# Comments on 802.3dg Draft 0.2

Philip Curran  
Brian Murray  
Jacob Riesco

- ▶ This presentation has some notes and comments on Draft 0.2
- ▶ Nomenclature
  - There are some conflicts with the signal names used in the PCS transmit bit ordering diagram and the pseudo code used to define the  $8N/(8N+1)$  block coding with respect to the 8b6T code groups

{slide 5 of [Riesco\\_3dg\\_02\\_10292024](#)} / Figure 199-5 of draft 0.2

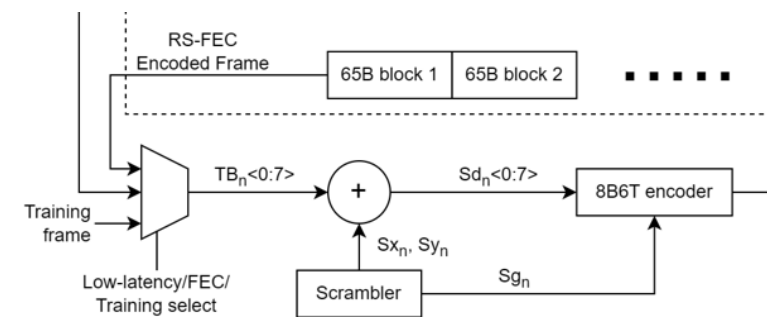
- ▶ The PCS transmit bit ordering diagram refers to the bits that are input to the scrambler as  $TB_n[0:7]$

- The NND symbols in a 4b6T or 8b6T 6-tuple have been referred to as  $\{TA_n, TB_n, TC_n, TD_n, TE_n, TF_n\}$  {slide 6 of [Curran\\_3dg\\_01a\\_01202025](#)}
- The pseudo code has used  $TD[n][0:7]$  {slide 10 of [Murray\\_3dg\\_01a\\_11132024](#)}
- Need to use a consistent nomenclature that does not conflict between different sections
  - We propose using  $Txb_n<0:7>$  for the bits that are input to the scrambler
- Need to spell out Non Negative Disparity (NND)

Figure 199-3 is a copy of Figure 146-4 and may need modification.

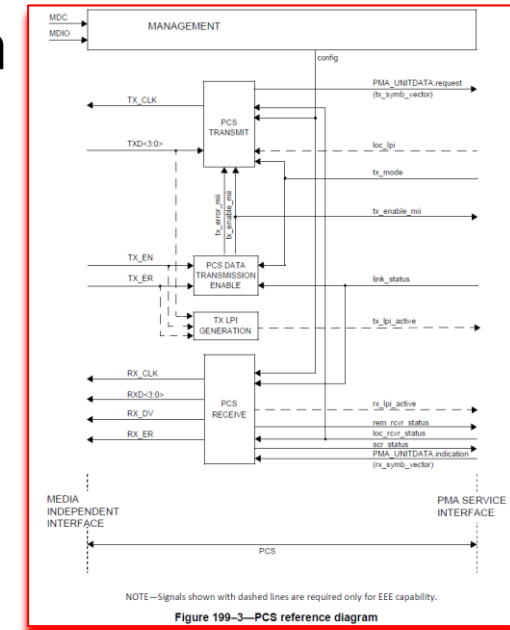
- ▶ Figure 199-3 (PCS reference diagram) has to be redrawn
  - Acknowledged in the Editor's note

- ▶ Figure 199-4 (PCS data transmission enabling state diagram) is not correct and may or may not be used

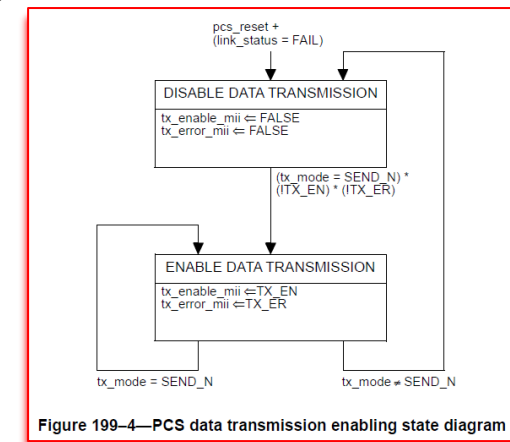
- There has been no discussion on this topic in the task force
- The use of this state machine will depend on how the text is updated to define the operation of the 8N/(8N+1) block coding

**Figure 199-1—Relationship of 100BASE-T1L PHY to the ISO/IEC OSI reference model and the IEEE 802.3 Ethernet model**

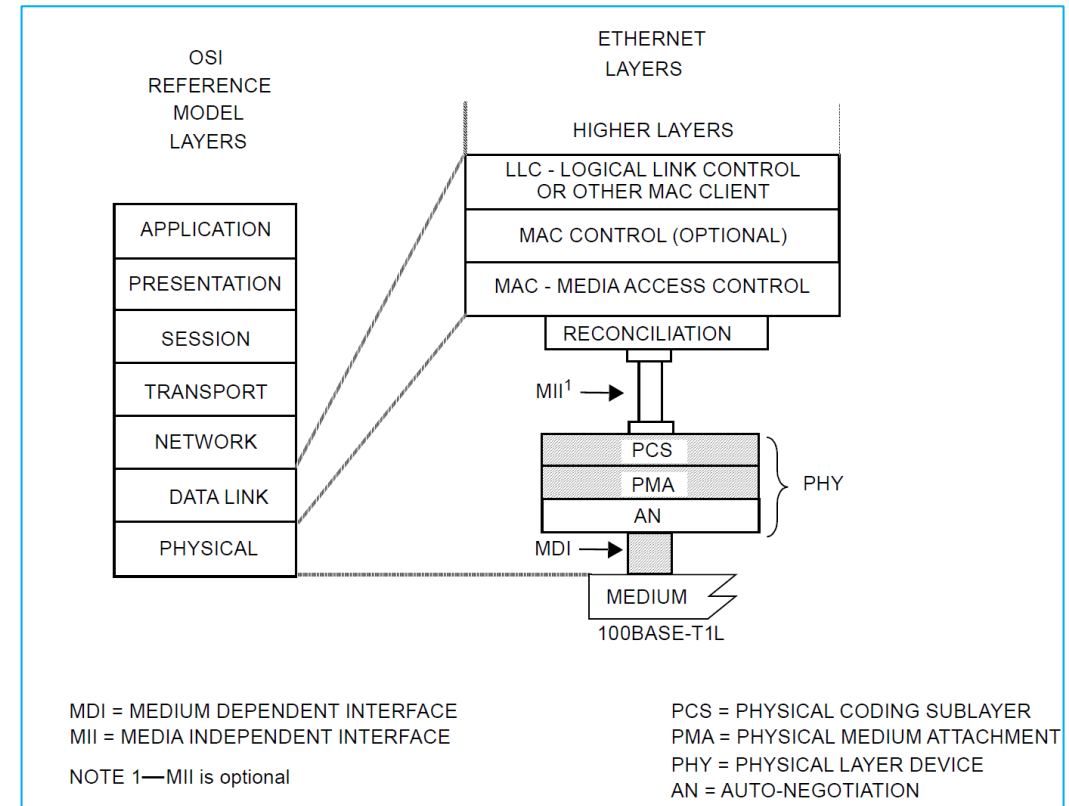
► Figure 199-1 (Relationship to the ISO/IEC OSI reference model) need to be updated, as Auto-Negotiation is not optional

- Remove “NOTE 2—Auto-Negotiation is optional”
- Acknowledged in the Editor’s note
